SP13-11: VALVE AHI ERREUR PPID 329 REV A - Feb 2013

Ref: production retrofit 13005 ON STOCK VEHICLES

AHI Valve 21534115

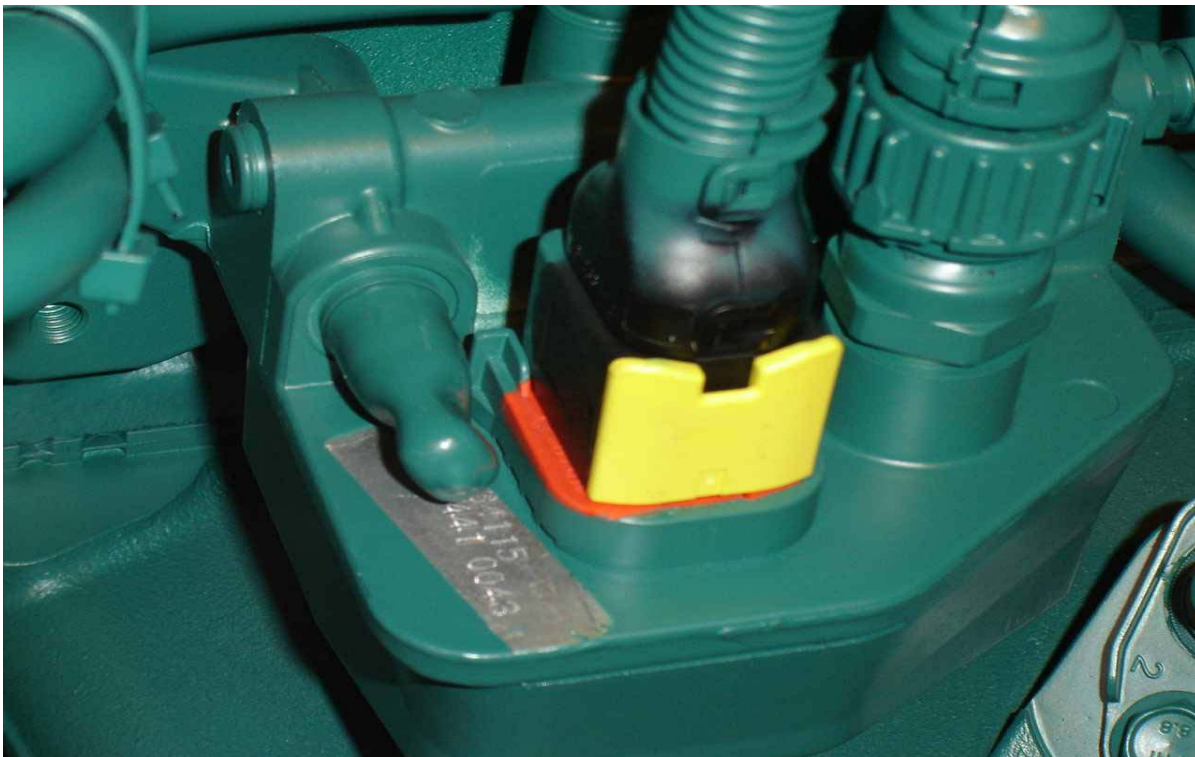
REPLACE THE AHI VALVE (AFTER TREATMENT HYDROCARBON INJECTOR)

ENGINE RIGHT SIDE

NEAR THE OIL GAUGE STEM

To be installed, replacement p/n 21534115 VALVE SHOULD HAVE A MANUFACTURING CODE OVER 12 W 335 0141

SERIAL NUMBER UNDER STICKER

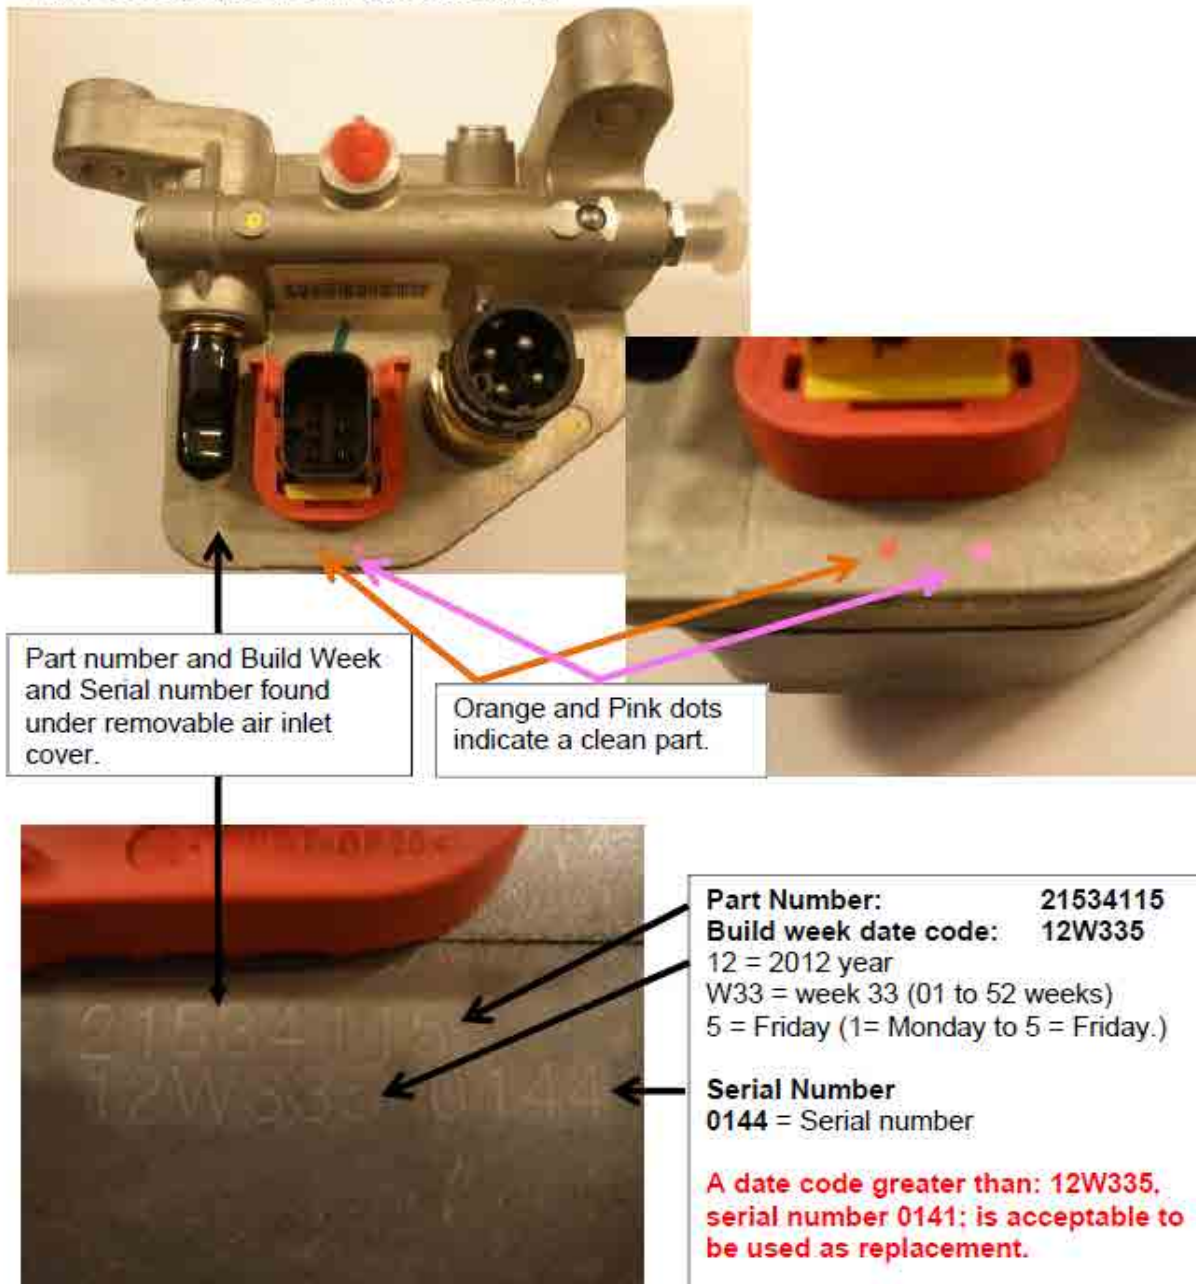
THE CODE IS UNDER REMOVABLE AIR INLET COVER
SEE PICTURE

RECORD VALVE SERIAL NUMBER IN THE RO;
